From: Scala, Mary Joy
Sent: Thursday, June 29, 2017 3:28 PM
To: 'Lockie Brown'
Cc: John Dewberry (JDewberry@dewberrycapital.com)
Subject: BAR Action - 200 E Main Street and 201 W Water Street - June 20, 2017

Re: Preliminary Discussion
BAR 17-06-11
200 East Main Street/201 East Water Street
Tax Parcel 280031000
Deerfield Square Associates II, Owner/Lockie Brown, Dewberry Capital, Applicant
Landmark Hotel

**CITY OF CHARLOTTESVILLE
BOARD OF ARCHITECTURAL REVIEW
STAFF REPORT
June 20, 2017**

Landmark Hotel

Height Study

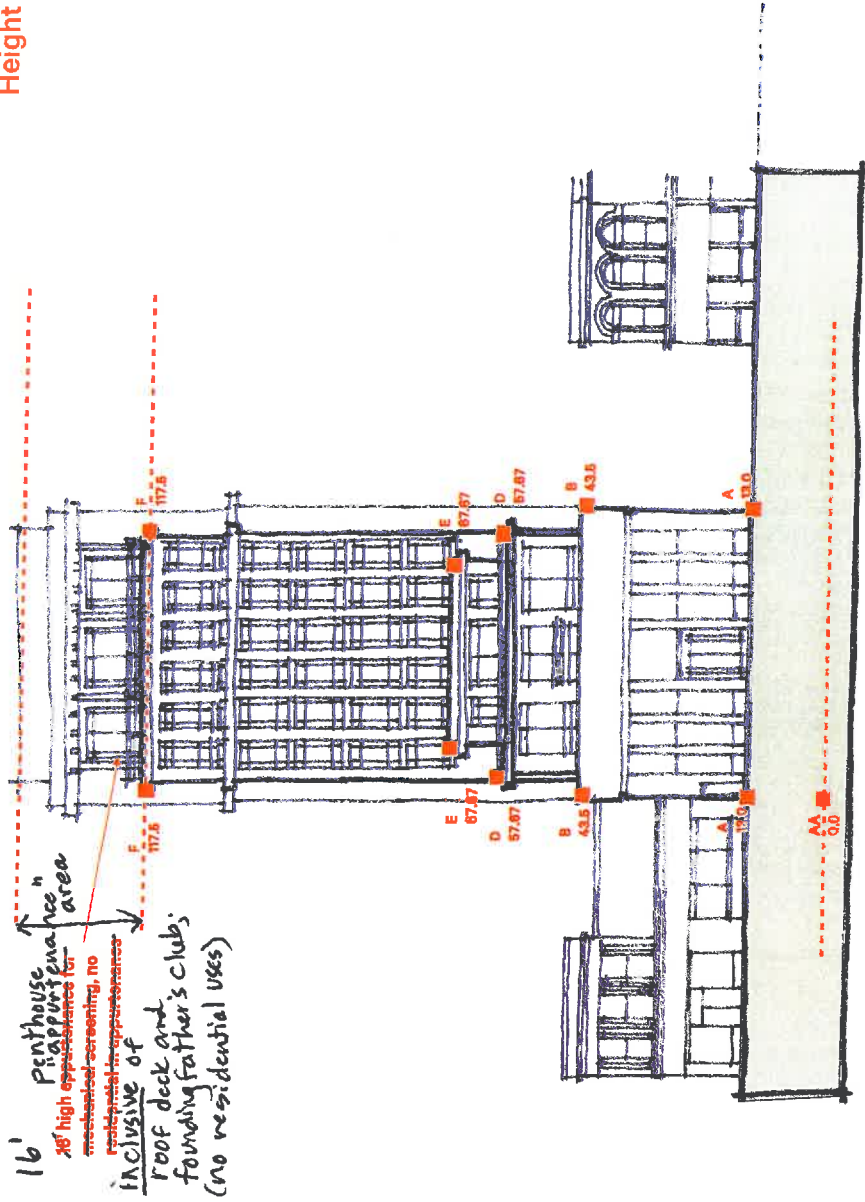
The existing black granite façade is approximately 30-feet tall, and approximately 12-feet deep. The 2016 Height Study illustrates a proposed addition to the Building that would sit partially on top of this granite façade. **The proposed addition would need to maintain a stepback of at least 10 feet from the granite façade facing Main Street (i.e., from the vertical plane represented by point (A to B) on the 2016 Height Study).**

I cannot ascertain, from the drawings submitted as the 2016 Height Study, whether this stepback requirement would be satisfied. (The horizontal line running between the points labeled “E” (57.67 feet) on the Main Street elevation appear to represent the top of the 5th story of the Building). **The façade of the proposed additional story, facing Main Street, would need to be stepped back at least 15 feet from the vertical plane represented by point (A to B) on the 2016 Height Study.**

Main Street Elevation:

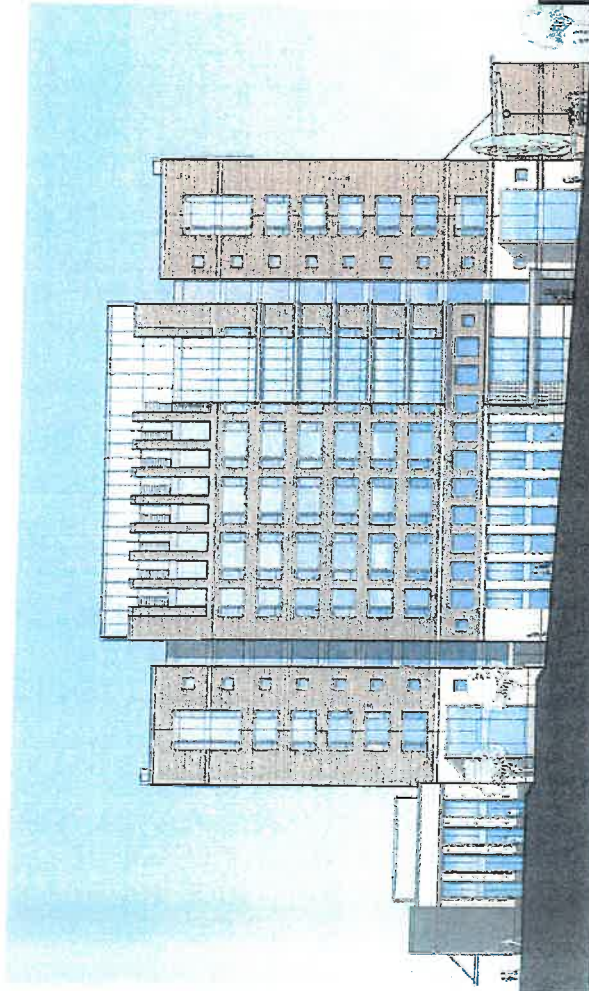
1. Butt glazed joint modification- *OK*
The guestroom windows previously had butt glazed joints shown. The joints were removed to avoid unsightly silicone sealant joints with clear glass.

2. Screen Wall- A mechanical screen wall was added through BAR approval to mask the mechanical units that service this building. *OK*
The screen wall height is adjusted to accommodate the actual mechanical units to be used.

3. Stair Egress- *OK*
A door was relocated to show as in plans.
4. Addition of pantry room bump out- *OK*
A bump out was added to accommodate the necessity for a pantry and storage for servicing the terrace.

5. Terrace Access - Doors now replace windows and a recessed portion is introduced. *align w/ window above*
Access in and out of the terrace for guests was added in a fashion to replicate the look of above the guestroom windows above. The recess is a function for the service of the guests.

6. Addition of coping- *OK as planned*
The original design did not take into consideration constructability and this lower "light box" needs a coping to match the roof coping.

7. Metal panel added - *Spandrel glass*
The metal panel continues across this window system for constructability purposes.

WATER STREET ELEVATION COMPARISON

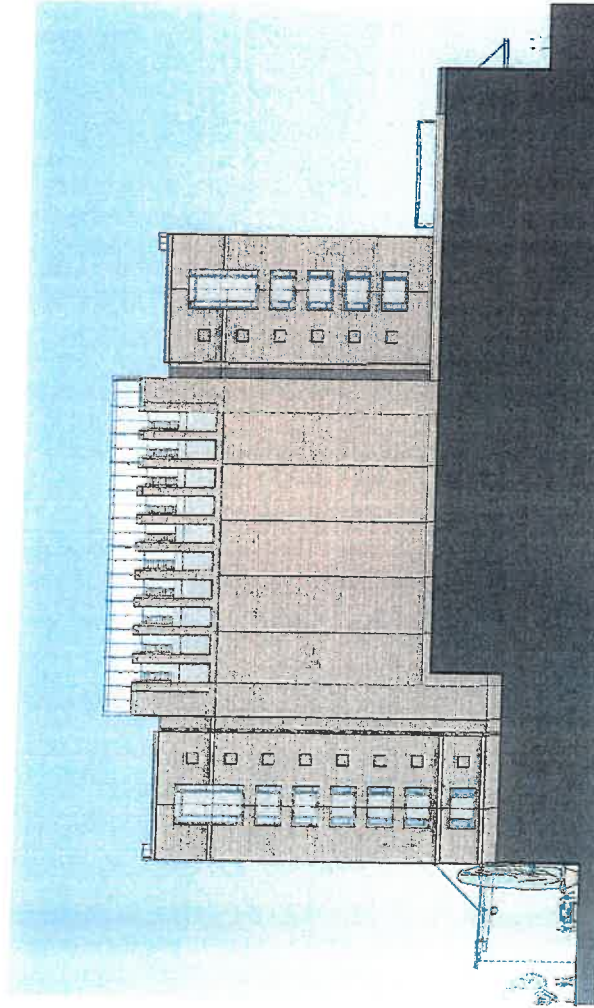
1. Canopy redesigned-
The canopy was changed and lowered through BAR approval.
2. Window modification- The window systems above and below new canopy now show some portions as glazing in head of metal panel and vice-versa.
This allows more natural light into public space and guestrooms. The windows heights were adjusted to actual structural elements. *not approved*

3. Stair Egress Door adjusted- *OK*
A door was relocated as per the plans.
4. Butt glazed joint modification- *OK*
The guestroom windows previously had butt glazed joints shown. The joints were removed to avoid unsightly silicone sealant joints with clear glass.

7. Metal panel added -
The metal panel continues across this window system for constructability purposes. *Spurred from*

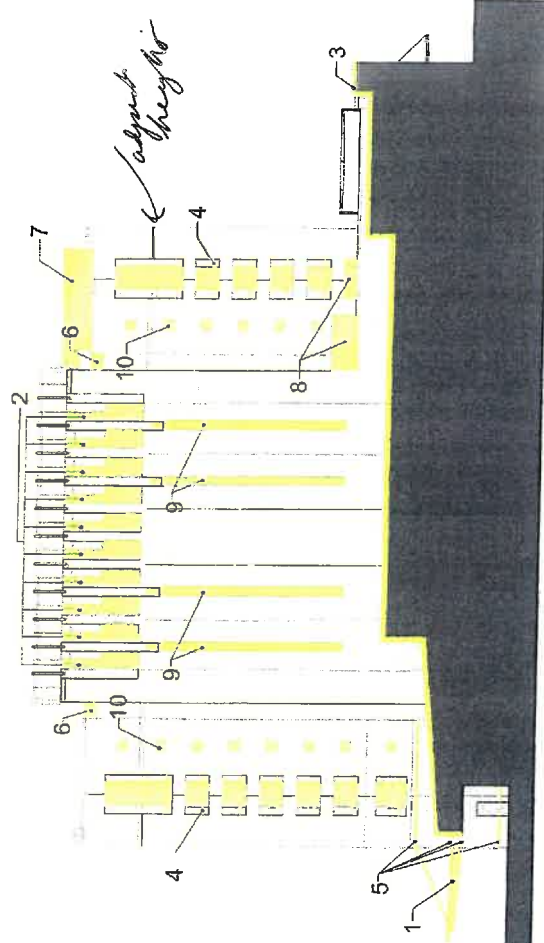
1. Canopy redesigned-
The canopy was changed and lowered through BAR approval.
2. Reduction of metal louvers- The louvers now show as glazing. *OK*
The louvers did not serve a function and it was replaced with glazing.

3. CVS party wall change-
The re-evaluation of the existing CVS party wall has been revised to show actual conditions. Since it was inaccurate in the original submission, the correct slope now shown will have modified some of the materials inaccurately shown near the Water street portion of this elevation. *OK*

4. Window/Butt glazed joint modification- *OK*
The guestroom windows previously had butt glazed joints shown. The joints were removed to avoid unsightly silicone sealant joints with clear glass. The windows were previously shown as metal panel and now are shown as glazing.

7. Screen Wall- A mechanical screen wall was added through BAR approval to mask the mechanical units that service this building. *OK*
The screen wall height is adjusted to accommodate the actual mechanical units to be used.

8. Addition of pantry room bump out- *OK*
A bump out was added to accommodate the necessity for a pantry and storage for servicing the terrace.

9. Brick detail addition- The brick "columns" from the light box were adjusted to stretch further down this elevation.
The unadorned blank brick wall needed detail to break of the monotony of the blank wall.
10. Brick Recess to Small Windows- The brick recesses adjacent to guestroom windows are now replaced by windows.
The small windows now serve the guestrooms to allow natural light in as well as match the Second Street elevation in look and function.
